**PLANNING CLEARANCE**  
GRAND JUNCTION COMMUNITY DEVELOPMENT DEPARTMENT

BLDG ADDRESS: 300 Cedar Ct.

DESCRIPTION OF WORK AND INTENDED USE: conversion of carport to family room, addition of master bedroom

Wagner  
300 Cedar Ct.

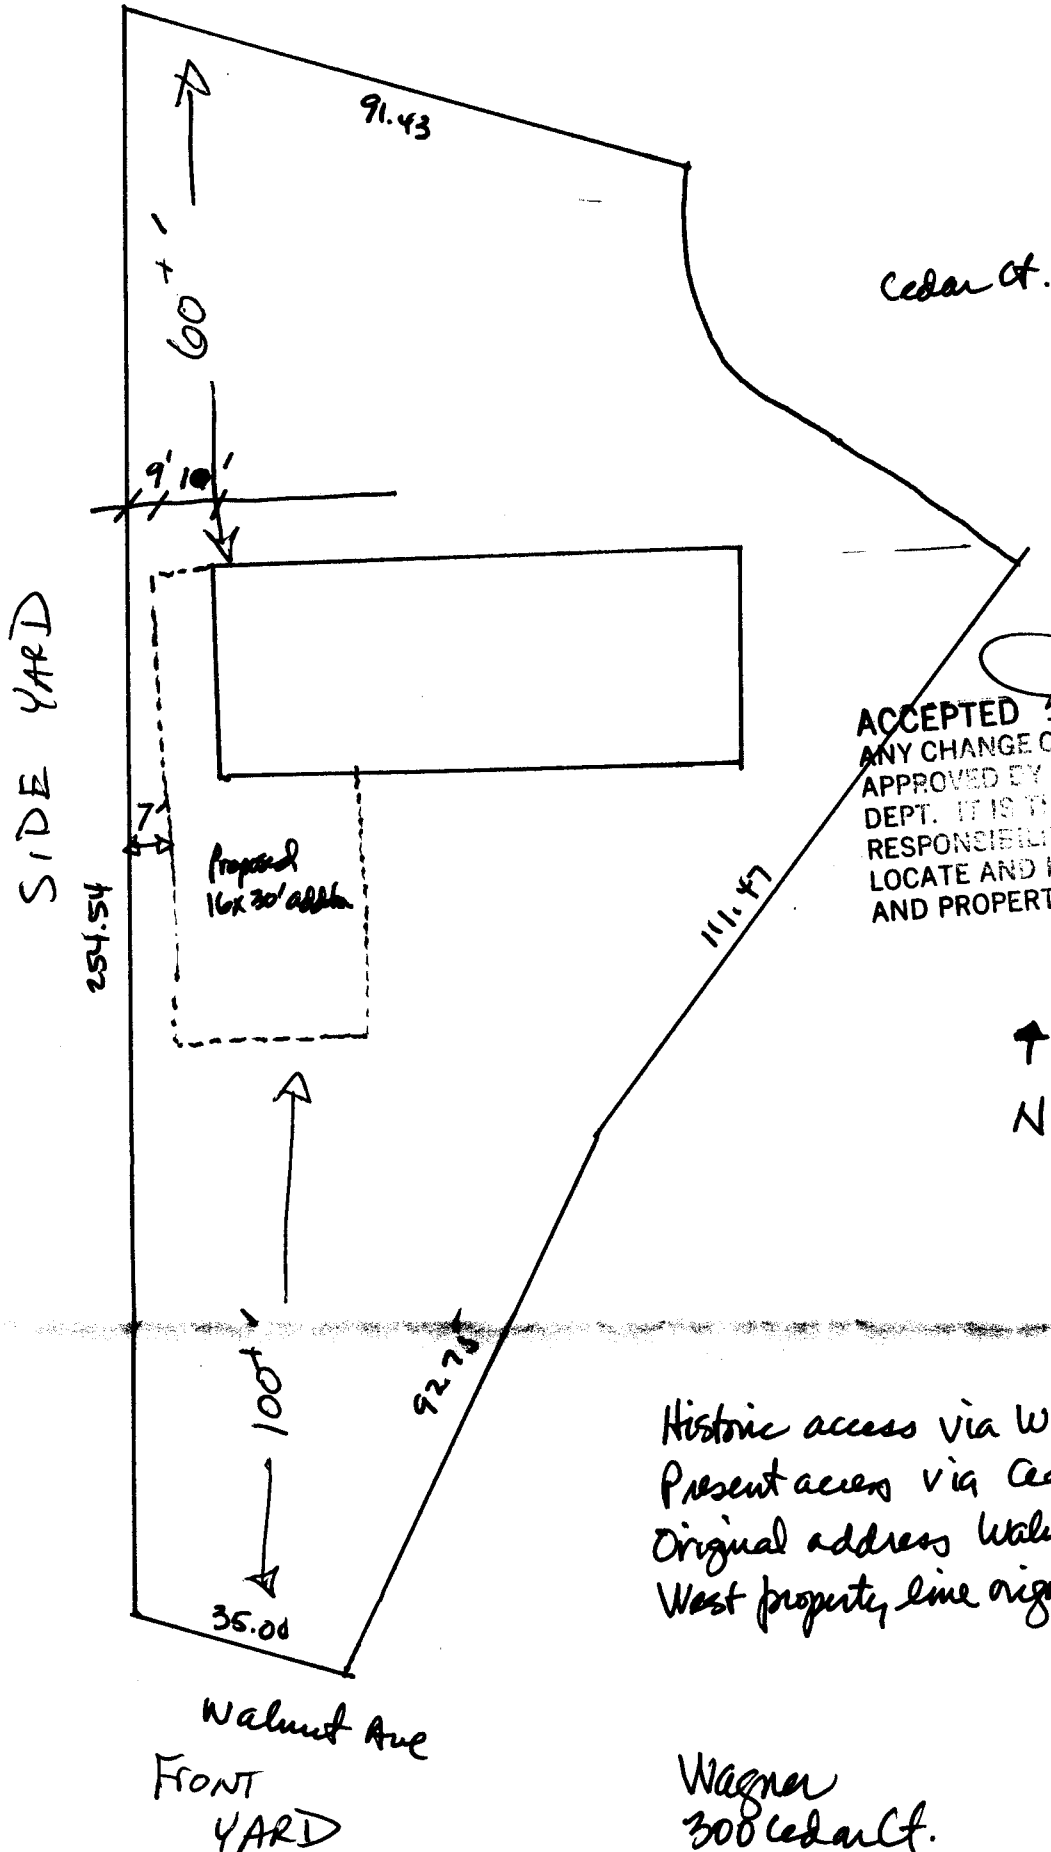
Bennett -  
 need administrative  
 interpretation -  
 side, rear,  
 front yards?  
 Dave & Kris

My request is that this be determined to be treated as a sideyard as it was originally treated.

Historic access via Walnut Ave.  
Present access via Cedar Ct.  
Original address Walnut Ave.  
West property line originally sideyard.

SPECIAL CONDITIONS: FRONT YARD SETBACK determined by 1959 Air photo to be off of WALNUT AVENUE ok by BB

ACCEPTED *[Signature]* 9-3-91  
ANY CHANGE OF SETBACKS MUST BE APPROVED BY THE CITY PLANNING DEPT. IT IS THE APPLICANT'S RESPONSIBILITY TO PROPERLY LOCATE AND IDENTIFY EASEMENTS AND PROPERTY LINES.
